Subject: Submittal of the Response to the Notice of Disapproval Baseline Geomorphic Conditions at Sediment Transport Mitigation Sites in Los Alamos/Pueblo Canyon Watersheds and Revision 1

**Response to the Notice of Disapproval for the Report on Baseline Geomorphic Conditions at
Sediment Transport Mitigation Sites in the Los Alamos and Pueblo Canyon Watersheds
Los Alamos National Laboratory EPA ID No: NM0890010515, HWB-LANL-08-004,
Dated January 31, 2011**

Baseline Geomorphic Conditions at Sediment Transport Mitigation Sites in the Los Alamos and Pueblo Canyon Watersheds, Revision 1

Figure 9 Cross sections in lower third of upper Pueblo Canyon willow-planting area

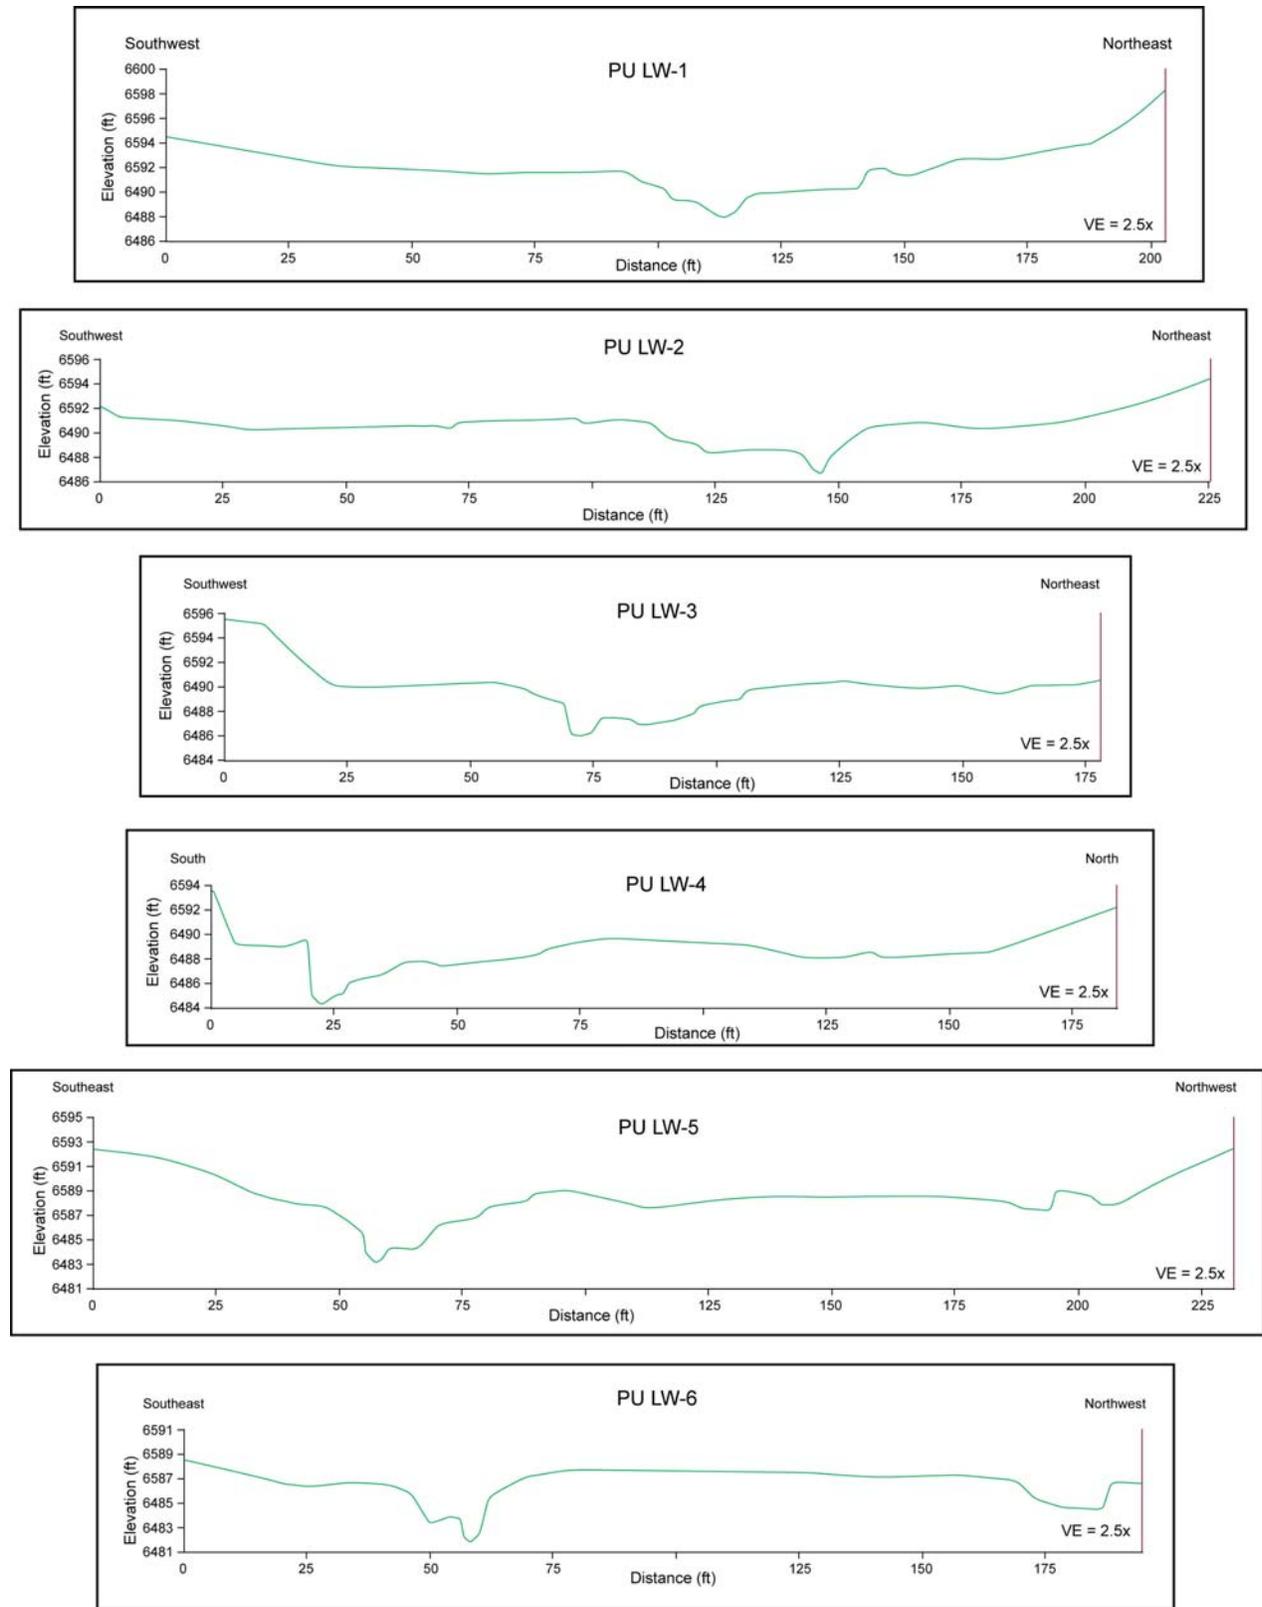
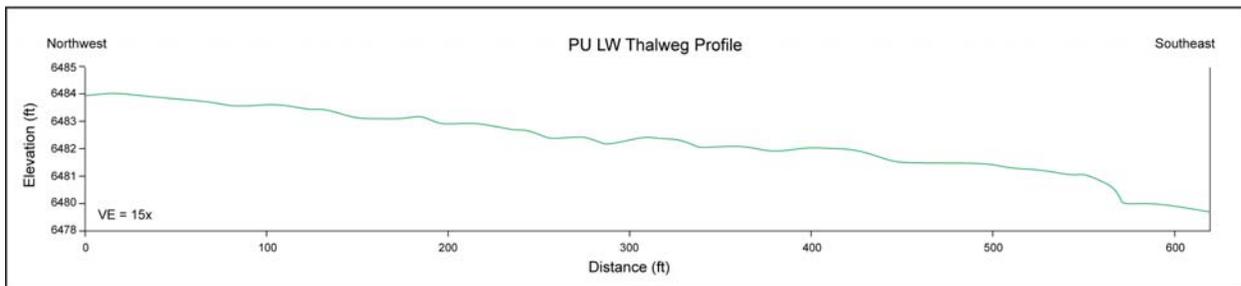
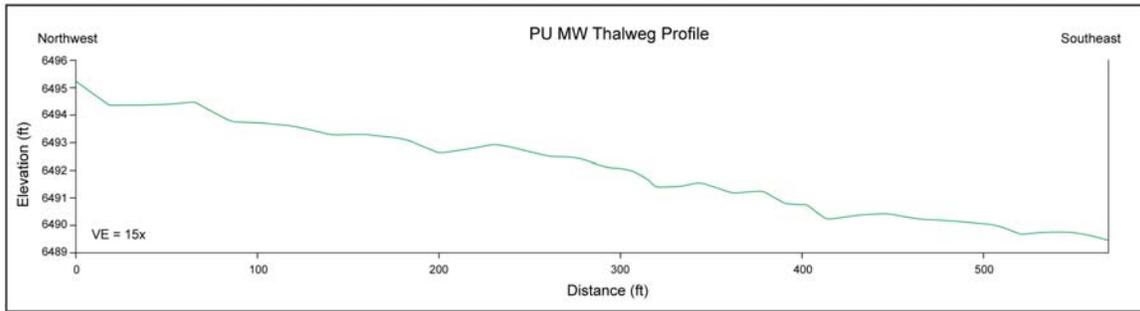
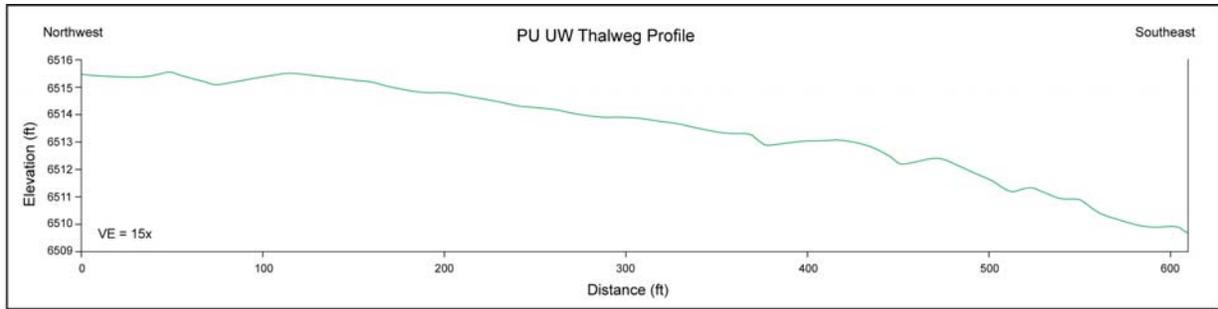
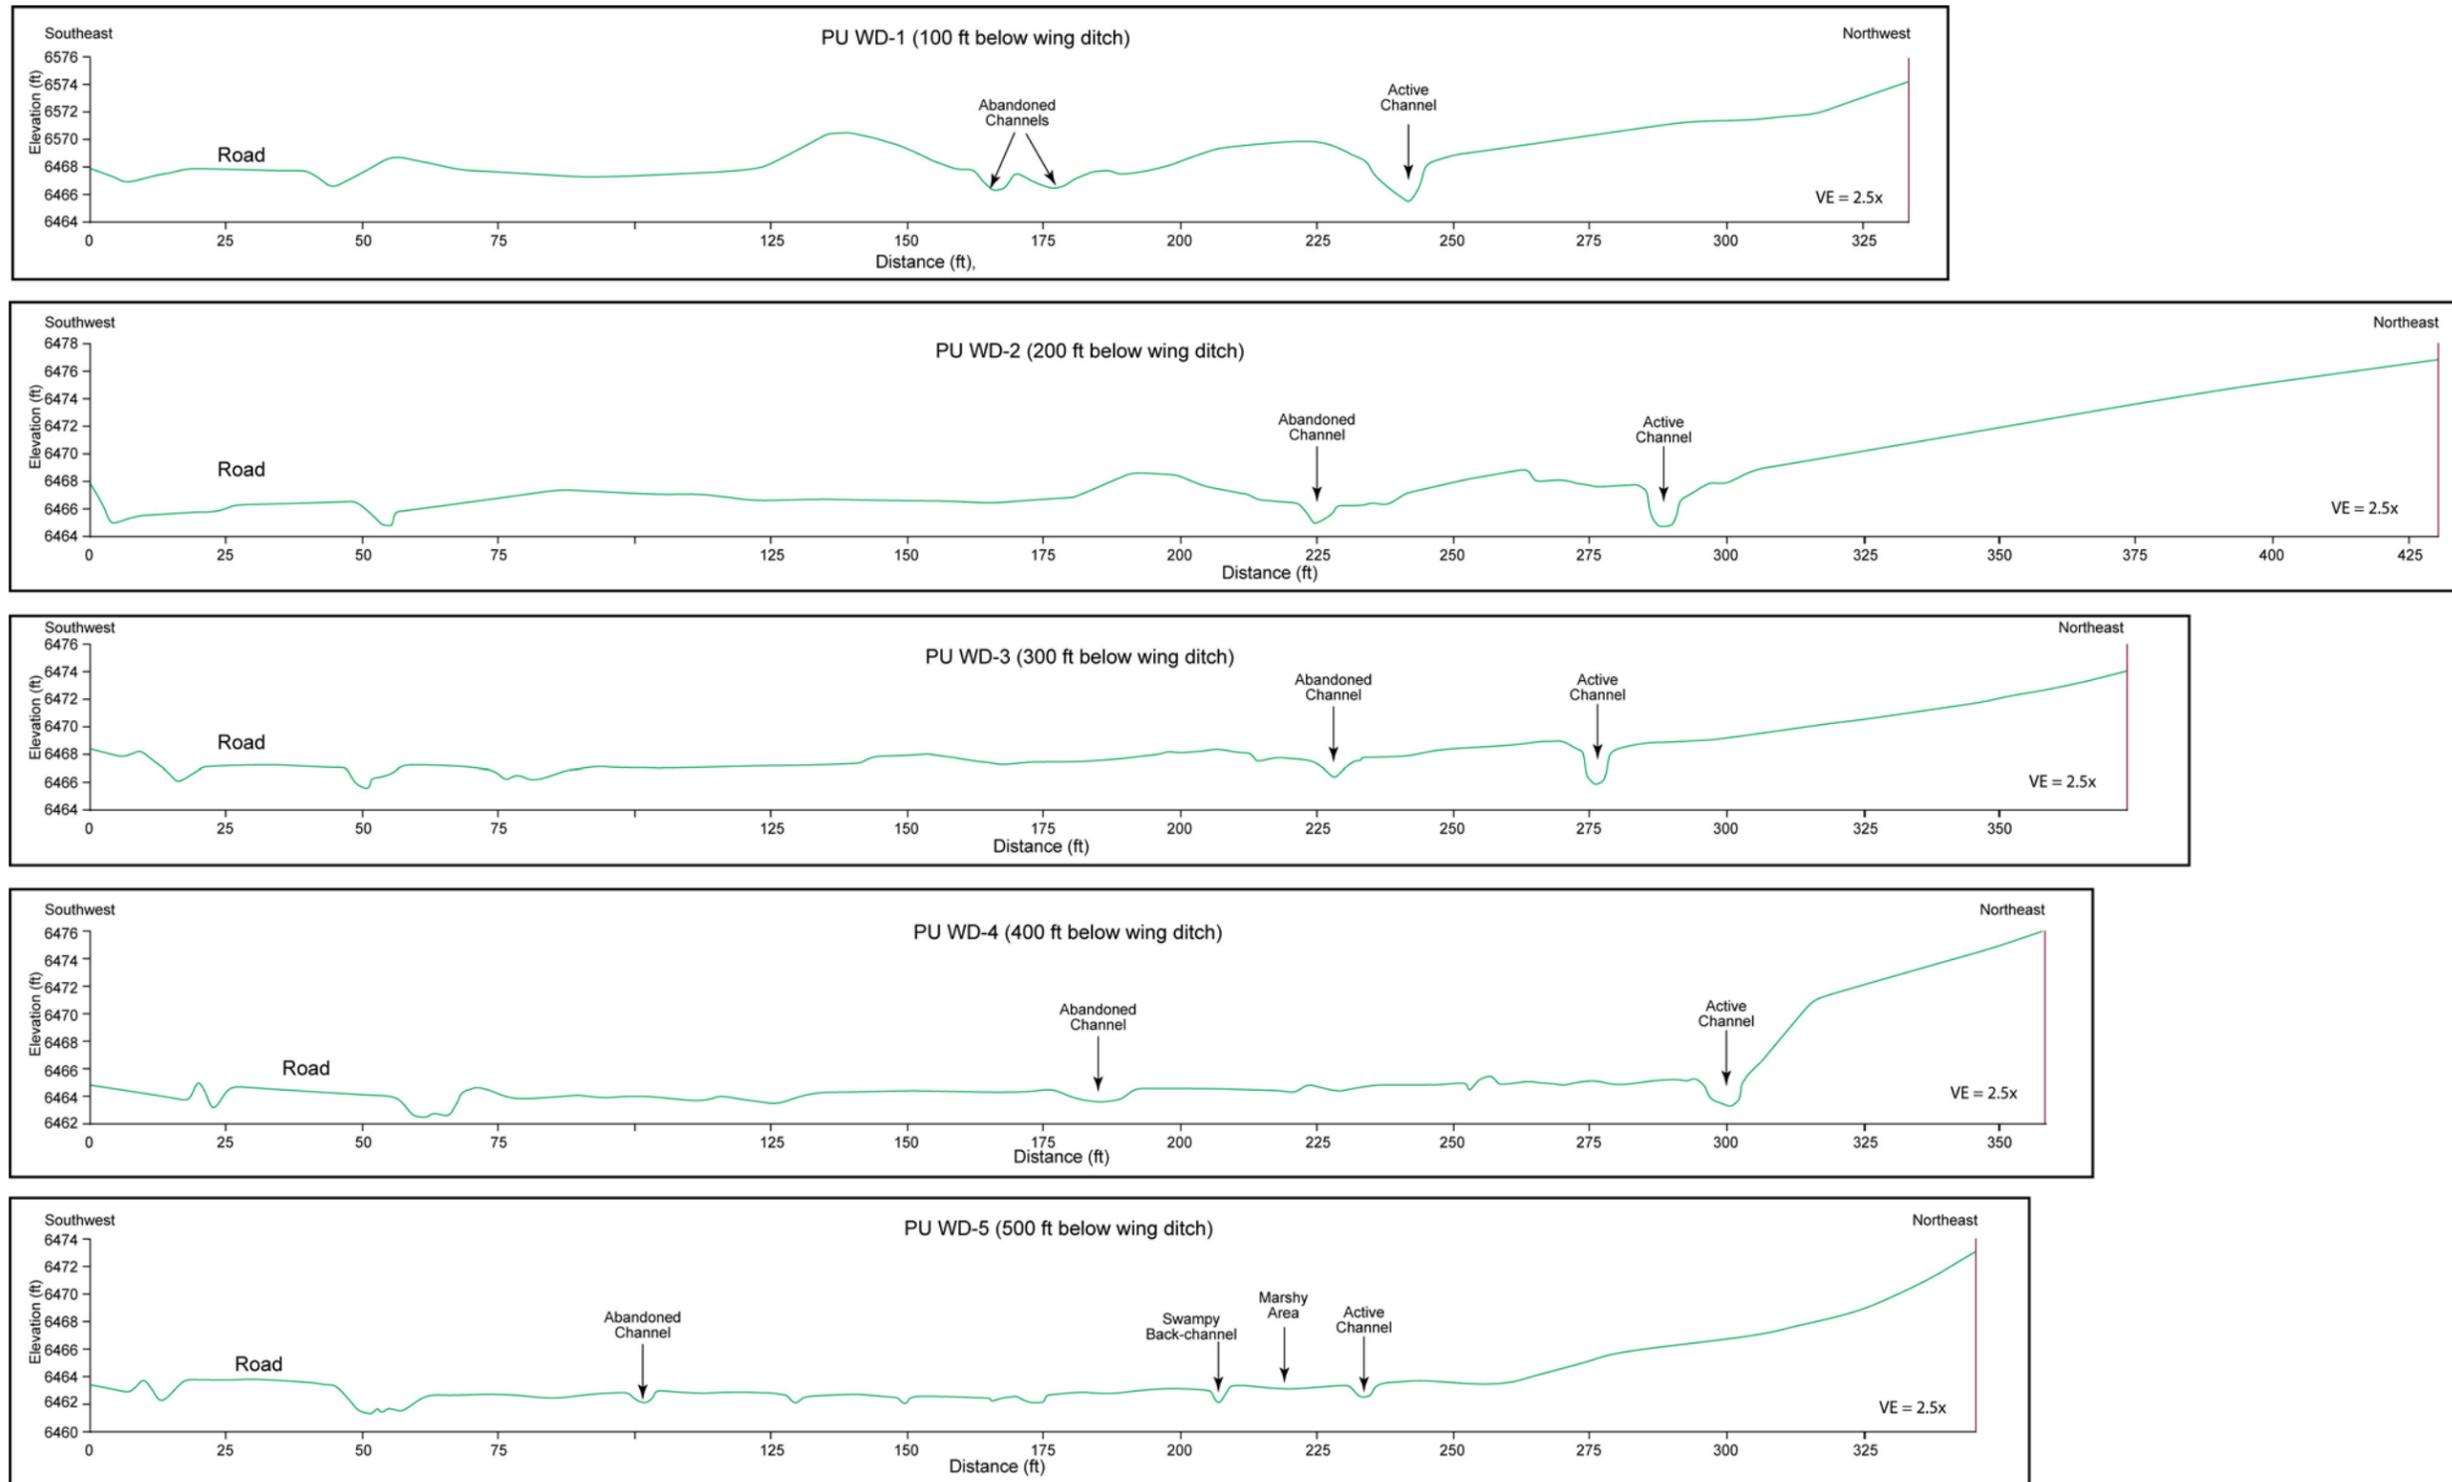
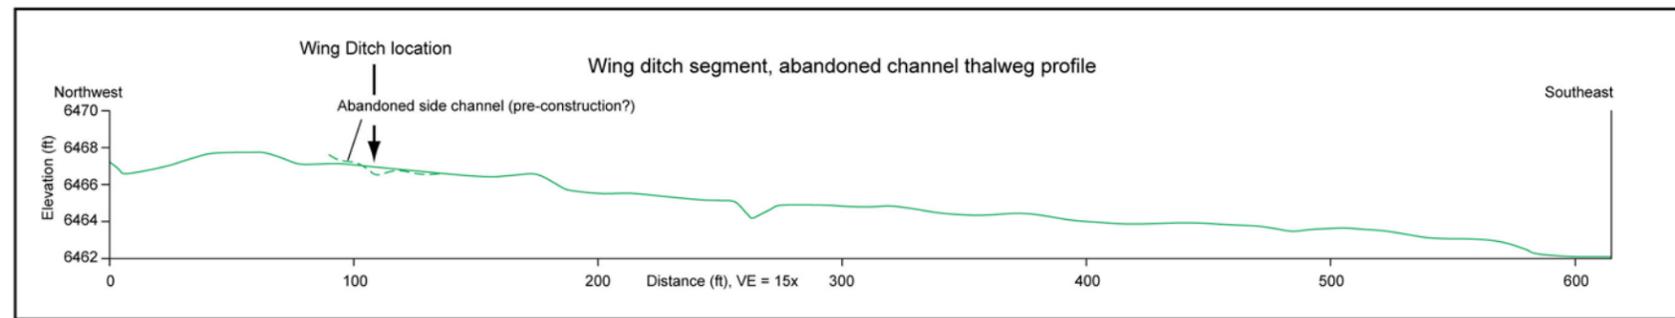
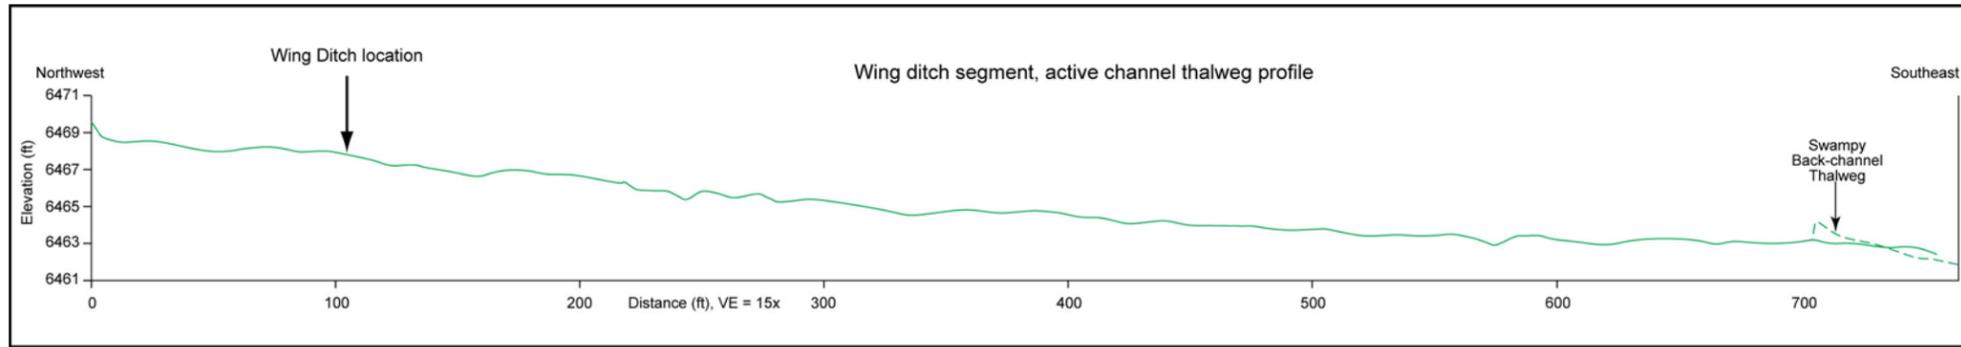
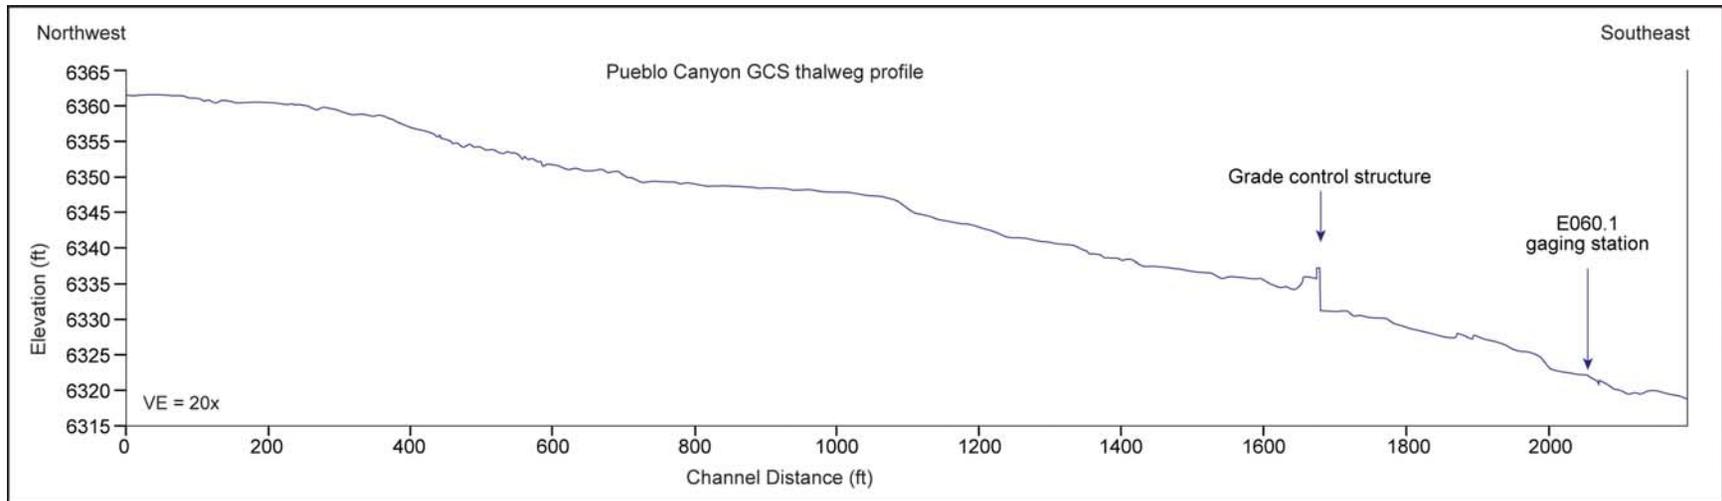
2. *Figures 3, 4, 5, 7, 8, 9, 10, 12, 13, 15, 16, 18, 19, 22, and 23 consist of multiple 2-dimensional graphs, with elevation on the Y axis and distance on the X axis, depicting cross sections and thalweg profiles. The survey data used to generate the graphs were provided by the Permittees in Attachment 1. According to the Permittees, a "Geodimeter 620 total station survey method" was employed to generate the graphs. NMED could not interpret the coordinates provided in Attachment 1 or reproduce the graphs as depicted in Figures 3, 4, 5, 7, 8, 9, 10, 12, 13, 15, 16, 18, 19, 22, and 23. Provide the data in a format that can be used by NMED to reproduce the graphs and evaluate the cross sectional features.*

2. The survey data were obtained using either a total station or a global positioning system and used the New Mexico State Plane coordinate system. Graphs were prepared using Excel software after first converting the x and y coordinates to distance from the end of each section or profile. This conversion involved basic trigonometry (Pythagorean theorem). Columns have been added to the tables in Attachment 1 showing the calculated distances along each section or thalweg profile for each survey point (excluding benchmarks). The text has also been revised to describe this conversion.
